Solid Earth Discuss.,
https://doi.org/10.5194/se-2019-121-RC1, 2019

Interactive comment on "Subsidence associated with oil extraction, measured from time-series analysis of Sentinel-1 data: case study of the Patos-Marinza oil field, Albania" *by* Marianne Métois et al.

Anonymous Referee #1

Review of " Subsidence associated with oil extraction, measured from time-series analysis of Sentinel-1 data : case study of the Patos-Marinza oil field, Albania" by Metois et al.

Fig. 1. Figure R1: Seismicity map around the Patos-Marinza oil fields. M>=4 earthquake, 1973-2019, from USGS catalogue. Black box is the schematic contour of the Patos and Mazrinza oil-fields.

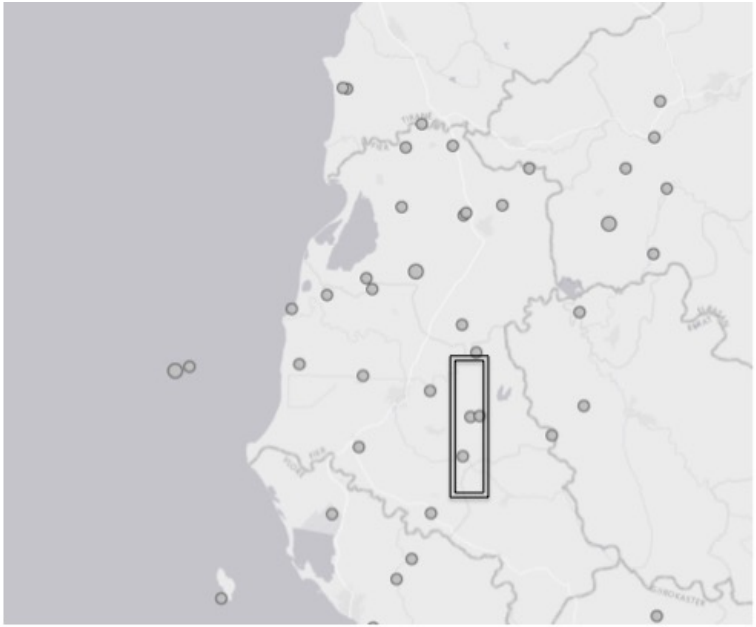
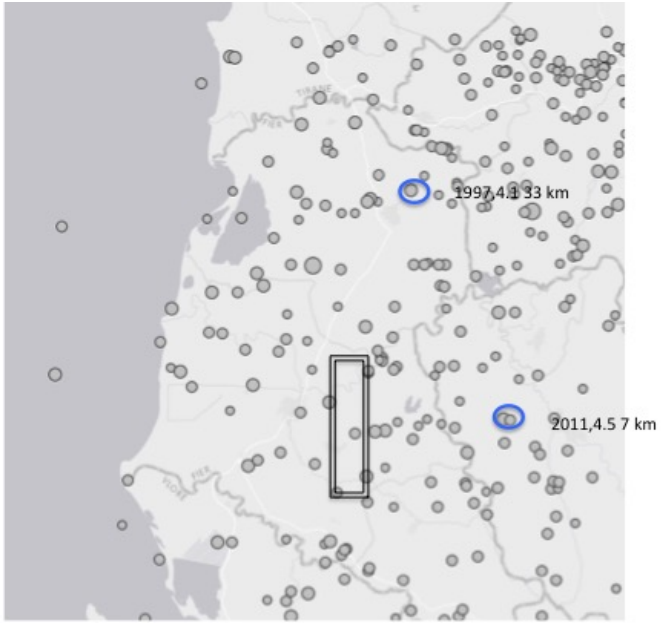
km under the zone of maximum subsidence". We will appreciate error bars on the meter accuracies of the equivalent reservoir dimensions. Also, if these values are not a-priori imposed, we need to know which ranges were tested for length, width, thickness during parameter tuning of the model. If not, we do not understand what the key outputs of the model are?âĂÍ earthquake triggering and Patos-Marinza fluid manipulations: - l10,p2: "Furthermore, drilling processes and fluid extraction can change the pore pressure and stress field in the mediumÂăso muchÂăthat anomalous seismic activity may be triggered". This point is out of context in the case of seismicity triggered by oil and gas recovery. One of the main lessons of anthropogenic seismicity related to hydrocarbon recovery is that earthquakes are triggered by small stress change, i.e., a few 0.1-01 MPa, the same order of magnitude of stress change than the ones that trigger aftershocks (e.g., for a review Foulger et al. 2018)Âă -l15,p2: "For instance, the seismicity observed in the Oklahoma oil and gas field and its relationship with wastewater disposal has been extensively studied in the last years (Murray, 2013; Walsh and Zoback, 2015". Here there is a problem because the authors use examples of wastewater injections, that is not similar to enhanced recovery technique, to support the triggering potency of enhanced recovery.Âă - Because no threshold for magnitude completeness is used, the analysis of seismicity patterns over space and in relation to subsidence and production are not robust. Any evidence for an increase in seismicity rate has to be tested not to be biased by a change in the earthquake recording thresholds (e.g.,ÂăJ Woessner,ÂăS WiemerÂă- Bulletin of the Seismological . . ., 2005). The lack of Mmin choice induces biases in seismicity rate changes as driven by change is instrumental network geometry. For all standard seismological studies, the regional choice for Mmin is derived from the frequency-size distribution of earthquakes. ÂăFor the anthropogenic event selection, a proper way to define anthropogenic seismicity at a given reservoir distance is to map different distance ranges and to extract up to which distance the seismicity differs from the background tectonic rate. As an example using the USGS database 1973-2018, M>=4 or M2.5, there is no evidence for earthquake clustering in the vicinity of the oil field (figure R1-2)?Âă - Most of the cited literature

relates to the case for wastewater injection (or gas withdrawal). There is no evidence for the wastewater injection to drive seismicity in this oil field. In the case of the shallow oil field, the initial pressure allows for smaller pressure drop than for gas fields, and it may be the reason why there is four times less reported cases for earthquake triggered by oil rather than gas extraction, respectively (e.g., for a review Foulger et al. 2018). A section that compares subsidence around the Patos-Marinza oil fields with other cases where oil extraction triggered subsidence and seismicity is missing.Âă As example l20, p16 “Such type of surface deformation is likely associated with stress changes in the neighbouring geological formations, which have been correlated with low to intermediate magnitude seismicity in several well-instrumented oil fields (e.g. Segall et al., 1994; Ellsworth, 2013; Keranen et al., 2013, 2014; Hornbach et al., 2016).” These four references are cited to support surface deformation and in-depth stress changes induced by oil recovery., but they are all out of context. Segall et al. 1994, reports on a 4-5 km depth, 65 MPa initial pressure, the gas field associated with a few cm subsidence cases, M4 seismicity. Ellsworth 2013 review paper and Keranen et al., 2013 and Hornbach et al., 2016 papers for Oklahoma and texas respectively, all the three reports entitled “Injection-induced earthquakes”, do not describe any subsidence data or extraction value, and focus on wastewater injection below reservoirs for which no data are available on the case study of Patos-Marinza fluid manipulation.Âă
